Proposal for editorial correction to ECE/TRANS/WP.29/GRE/42

(Collective amendments to Regulations Nos. 3, 6, 7, 48, 77 and 91)

A. Proposal for Supplement 11 to the 04 series of amendments to Regulation No.48

Figure (see paragraph 6.5.)

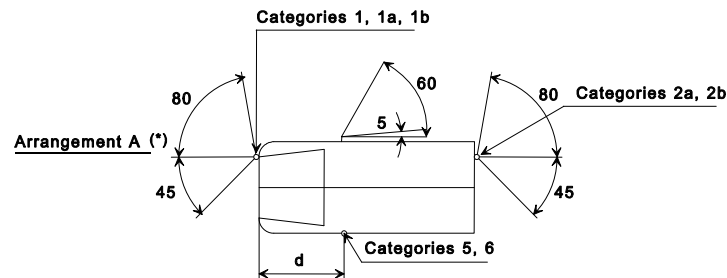
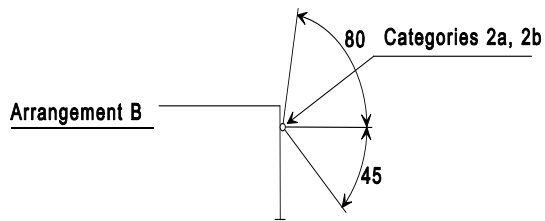
~~Vertical angles: 15° above and below the horizontal for direction indicator lamps of categories 1, 1a, 1b, 2a, 2b and 5. The vertical angle below the horizontal may be reduced to 5° if the lamps are less than 750 mm above the ground; 30° above and 5° below the horizontal for direction indicator lamps of category 6. The vertical angle above the horizontal may be reduced to 5° if the optional rear lamps are not less than 2,100 mm above the ground.~~

~~For M1 and N1 category vehicles, the value of 45° inward for the direction indicator lamps of categories 1, 1a or 1b, whose lower edge of the apparent surface is less than 750 mm above the ground, may be reduced to 20° under the horizontal plane containing the reference axis of this lamp.~~

Vertical angles: 15° above and below the horizontal for direction indicator lamps of categories 1, 1a, 1b, 2a, 2b and 5.

- where a lamp is mounted below 750 mm (measured according to the provisions of paragraph 5.8.1), the downward angle of 15° may be reduced to 5°;
- where an optional rear lamp is mounted above 2,100 mm (measured according to the provisions of paragraph 5.8.1) the upward angle of 15° may be reduced to 5°.

30° above and 5° below the horizontal for direction indicator lamps of category 6.

For the direction indicator lamps of categories 1, 1a, or 1b, 2a and 2b mounted below 750 mm (measured according to the provisions of paragraph 5.8.1), the inward angle of 45° may be reduced to 20° under the H plane.

6.5.5.2. or, at the discretion of the manufacturer, for M₁ and N₁ category vehicles: Front and rear direction indicator lamps, as well as side-marker lamps (**).

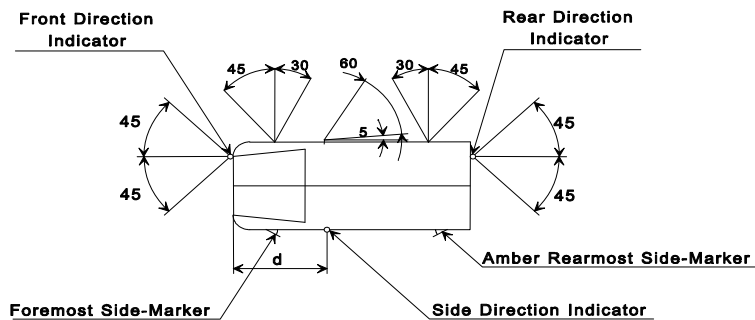
~~The value of 45° inward for the direction indicator lamps of categories 1, 1a or 1b, whose lower edge of the apparent surface is less than 750 mm above the ground, may be reduced to 20° under the horizontal plane containing the reference axis of this lamp.~~

~~Vertical angles: 15° above and below the horizontal. The vertical angle below the horizontal may be reduced to 5° if the lamps are less than 750 mm above the ground.~~

However, for the direction indicator lamps of categories 1, 1a, or 1b, 2a and 2b mounted below 750 mm (measured according to the provisions of paragraph 5.8.1), the inward angle of 45° may be reduced to 20° under the H plane.

Vertical angles: 15° above and below the horizontal. However, where a lamp is mounted below 750 mm (measured according to the provisions of paragraph 5.8.1), the downward angle of 15° may be reduced to 5°.

Add a new diagram and associated text, to read:

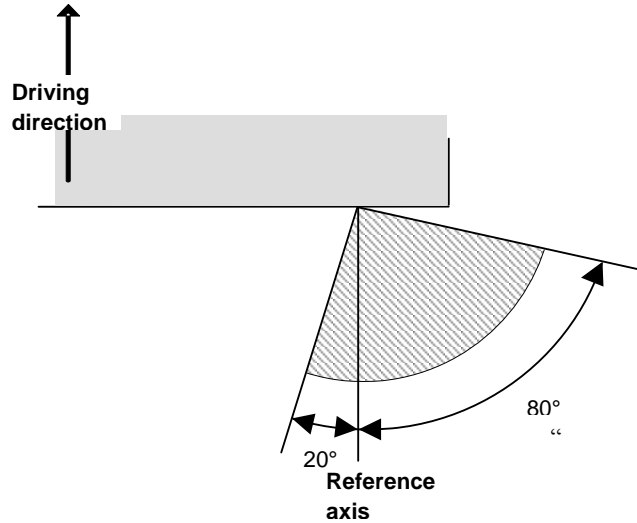
- (a) Direction indicator lamps **intended to be installed with the H plane the reference axis of the lamp at** with a mounting height of ~~equal to or~~ less than 750 mm above the ground, for which they are 15° above and 5° below the horizontal;
- (b) **Optional direction indicator lamps intended to be installed with the H plane the reference axis of the lamp at a mounting height of more than 2100 mm above the ground, for which they are 5° above and 15° below the horizontal;**
- (c) Direction indicator lamps of Category 6, ...

Under the H plane for lamps intended to be installed with this plane at a mounting height less than 750 mm above the ground.

Add a new diagram and associated text, to read:

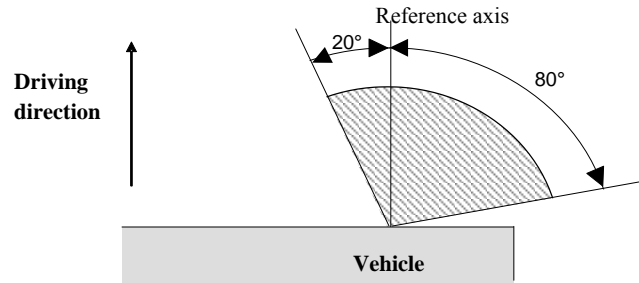
~~On and above the H
plane for all lamps.~~

Under the H plane for front position lamps intended to be installed with this plane at a mounting height less than 750mm above ground.
